THIRD READING SUMMARY SHEET

ZONING CASE NUMBER: C814-2012-0160

211 South Lamar Boulevard Planned Unit Development

ZONING CHANGE REVIEW SHEET

ENV. TREE
PUD EXHIBIT

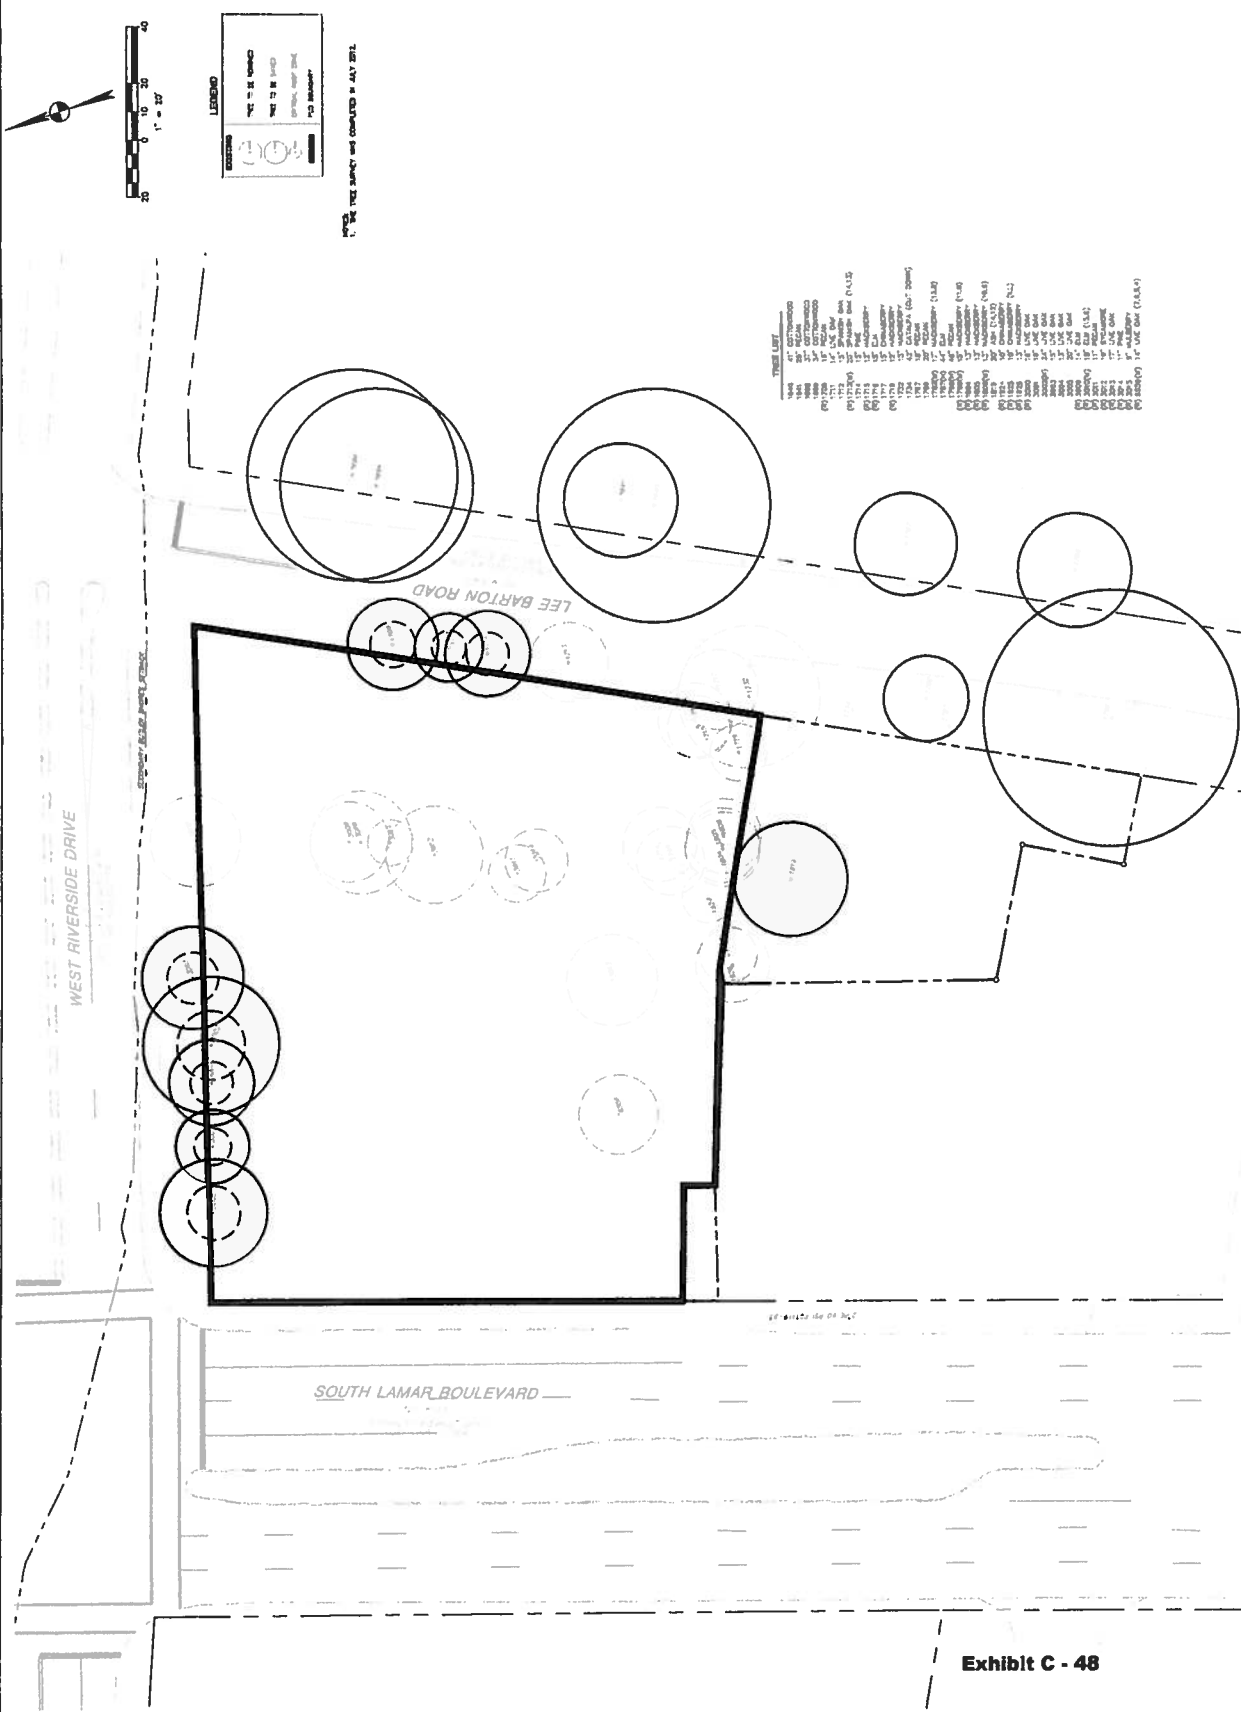
UPDATE #1 Note # 32 addresses the tree preservation criteria required to preserve trees in the PUD. The Env. Tree PUD Exhibit, sheet 4, shows tree #1709 to be removed in the list when it is supposed to remain, and it shows tree 1732 with a 50 ft CRZ instead of a 30 ft CRZ as stated in the tree survey list. Please correct these inconsistencies. This comment can be cleared informally.
